# UNITED STATES PATENT AND TRADEMARK OFFICE

APPLICATION NO.	FILING DATE	FIRST NAMED INVENTOR	ATTORNEY DOCKET NO.	CONFIRMATION NO.
10/009,936	12/10/2001	Gilles Bos	33900-90PUS	4569

# Office Action Summary

**FIG. 5**

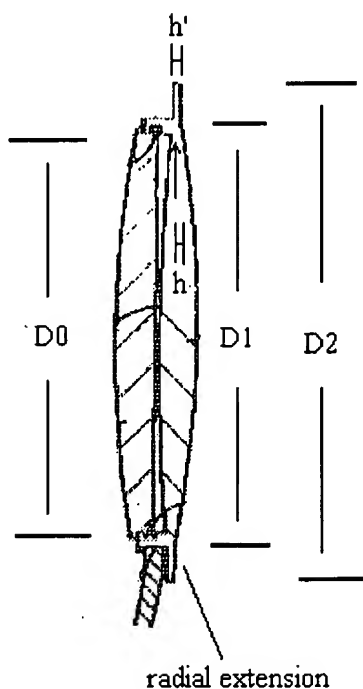
As seen in Figure 5 (see Figure 5 below), Weiser discloses an intraocular implant comprising an optical portion having an optical axis, a periphery having at least one connection zone, an anterior optical surface (lens 92), a cylindrical peripheral surface (ring 94) having a diameter and *a length h* (emphasis added) measured parallel to said optical axis, a posterior optical surface (lens 90) defined by a spherical cap, at least one haptic element (haptics 16, 18) having a posterior face and a connection end for connection to a respective connection zone of said periphery of said optical portion, and at least one radial extension (see L-shaped ends formed by ring 94 and lens 90) projection out of said cylindrical peripheral surface.

Each of said radial extensions having an anterior face, a side face, and a posterior face. Said side face of said radial extension disposed on a ruled surface having a diameter D2, said diameter D2 being greater than said diameter D1, said side face having *a length h'* (emphasis added) measured parallel to said optical axis and being substantially equal to said length *h* of the cylindrical peripheral surface. The connection end of the haptic element is connected to the periphery of said optical portion via said anterior face of said radial extension outside said anterior optical surface of said optical portion. Each radial extension constitutes a step formed by the offset between said posterior optical surface of said optical portion and said posterior face of each said haptic element. Each said side face of each said radial extension forms a square-edged portion with said posterior face of said radial extension. The anterior optical surface is bounded by a circle having a diameter D0 that is less than the diameter D1.

c. Applicants argue, "it is the length of ring 94 which must be compared to the defined length  $h$  of the cylindrical surface". Examiner respectfully disagrees. The claimed language requires: (i) a cylindrical peripheral surface having a length  $h$ , (ii) a radial extension having a side face having a length  $h'$ , and (iii) length  $h$  being substantially equal to length  $h'$ . First of all, where is the demarcation or boundary between the "anterior optical surface 24", the "posterior optical surface 26", the "radial extensions 30, 32", and the "cylindrical peripheral surface having a diameter"? Second, the claim requires *a length*, which could be broadly interpreted as any portion along the "cylindrical peripheral surface" thickness and any portion along the "radial extension having a side face having a length  $h'$ " thickness. Third, both lengths (i.e., " $h$ " and " $h'$ ") are substantially equal. These limitations are shown in Figure 5 of Weise '958.
